Technical Bulletin

Bulletin No.: PRO-02-02

Subject: DD-3 TYPE 30 SERVICE DIAPHRAGMS

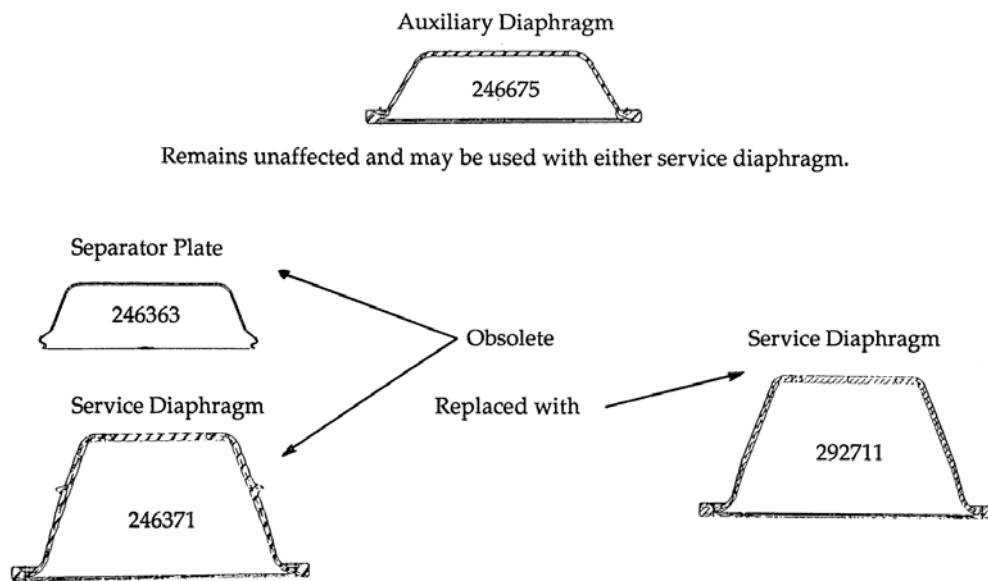
Effective 4/20/88, the type 30 DD-3 service diaphragm, part number 246371 and diaphragm separator plate 246363 are obsolete and superseded with diaphragm 292711. Diaphragm 292711 does not require the use of a separator plate to prevent "scuffing or sticking" between it and the auxiliary diaphragm.

When replacing diaphragm 246371 with part number 292711, the diaphragm separator must be discarded. Replacement diaphragm 292711 does not incorporate a retention bead to secure the separator plate.

Service kit 265071 contains one service diaphragm 292711 and one auxiliary diaphragm 246675. This kit can be used to service any type 30 DD-3 Safety Actuator.
